**STATE OF VERMONT
AGENCY OF TRANSPORTATION**

Town Of	RIPTON	Bridge No.	BRIDGE #17
Highway No.	TH 18	Log Sta.	
		Surv. Sta.	
TH 18 OVER SOUTH BRANCH MIDDLEBURY RIVER ABUTMENT MASONRY			
Designed By	Y I LIU	Drawn By	W J GAYNOR
Checked By	B P GUZAS	Bridge Design Supervisor	R L JOY
	8/09		Date 10/09
PROJECT	RIPTON	PROJECT NO.	FH 010-1(2)
I.G.C. Info.			
Bridge Sheet No.	Sheet 19R of 26

ABUTMENT 1

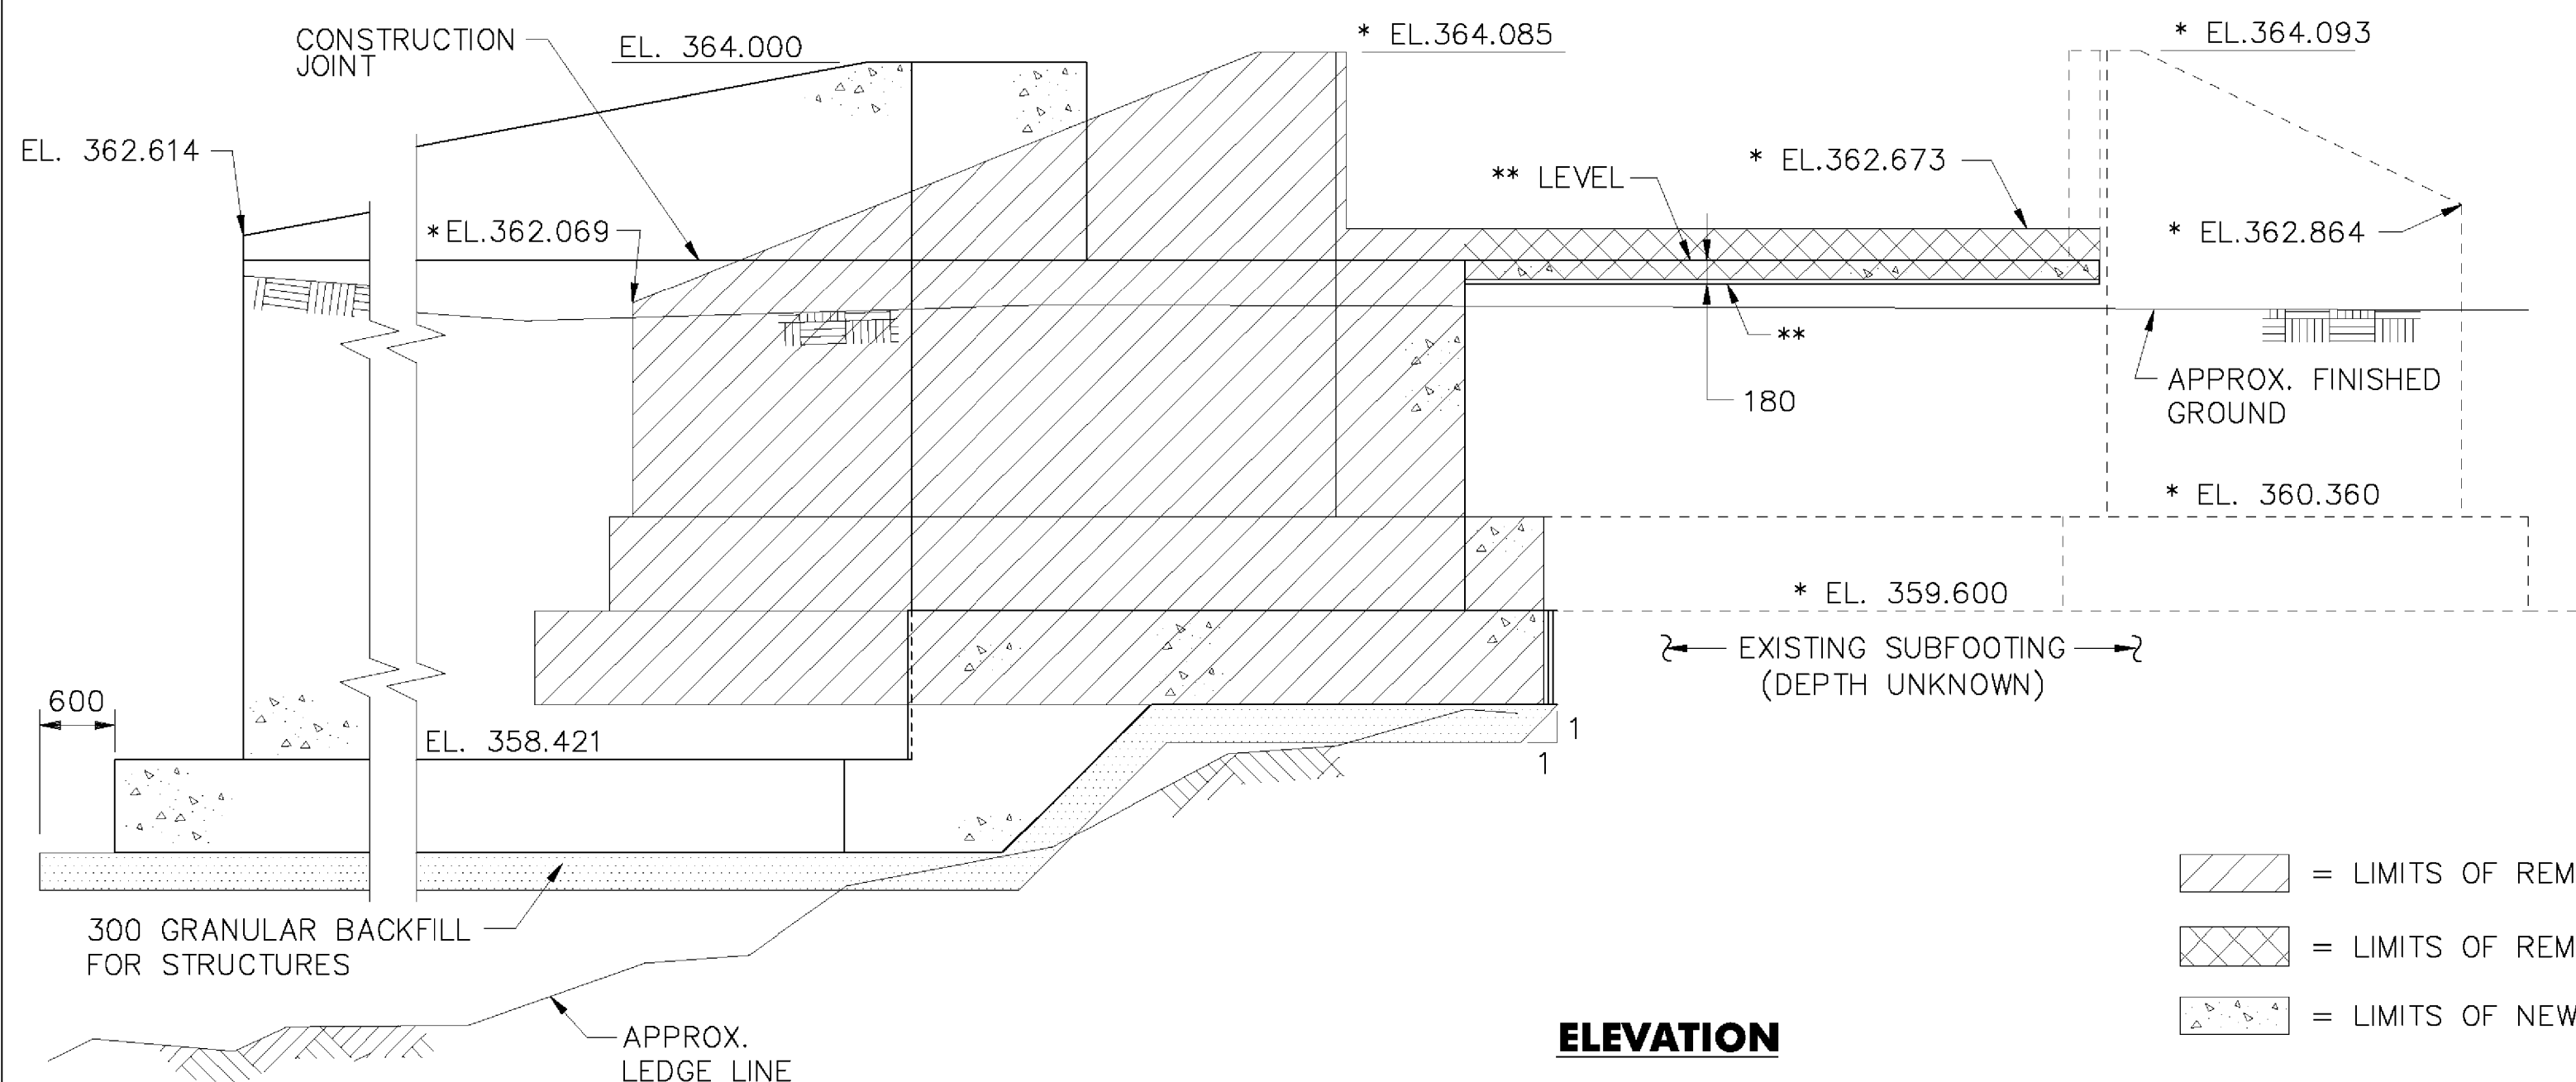
* WW #3 WORK DEEMED
UNNECESSARY

ABUTMENT 2

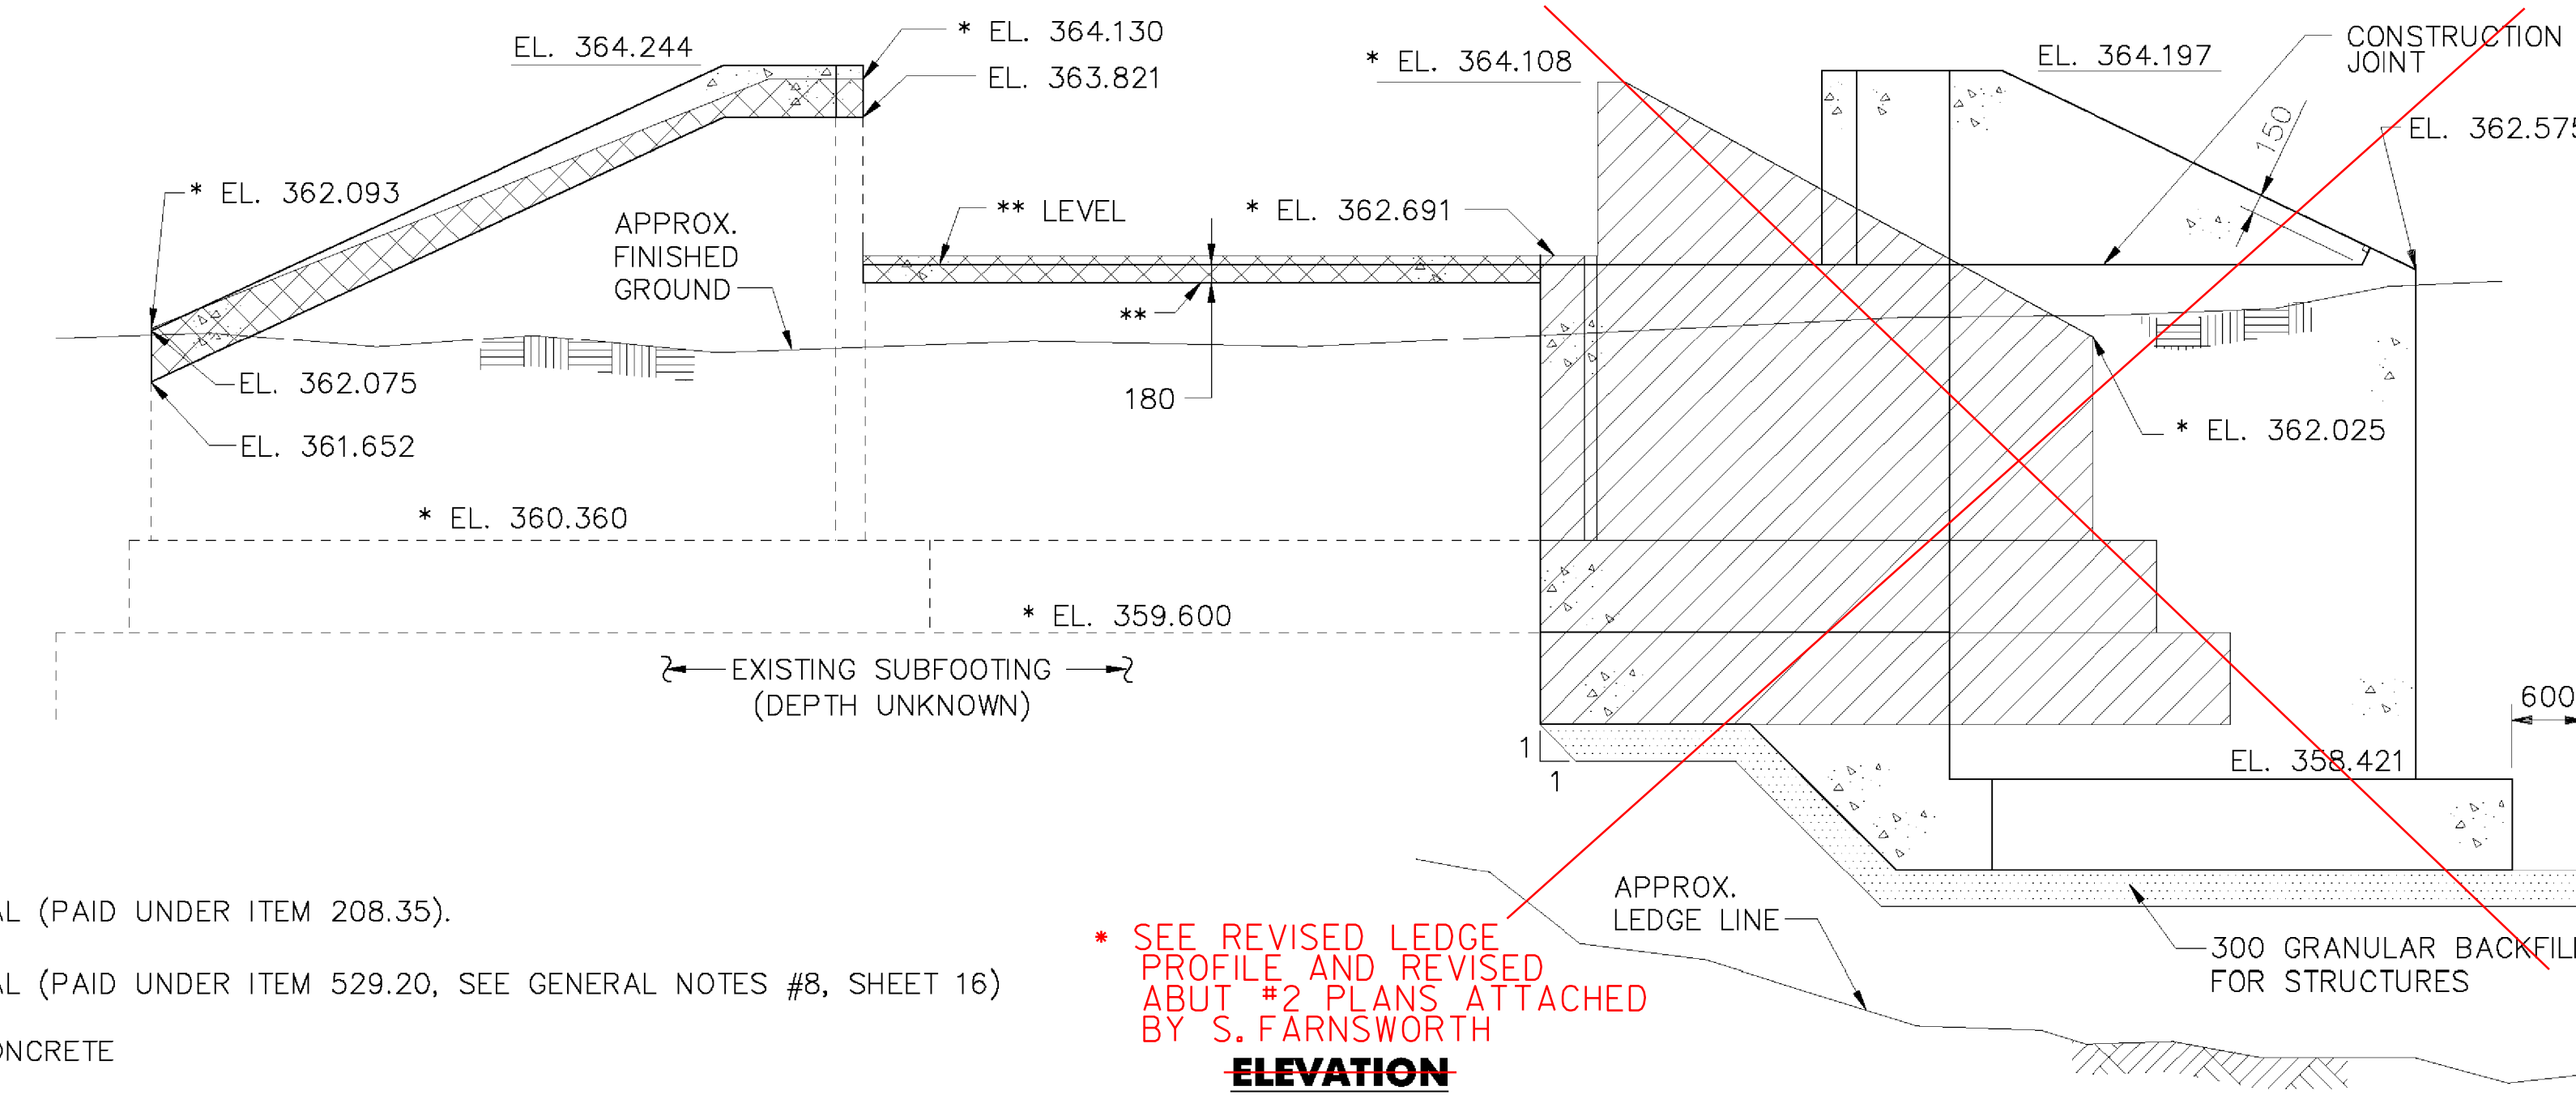
* SEE REVISED LEDGE
PROFILE AND REVISED
ABUT #2 PLANS ATTACHED
BY S. FARNSWORTH
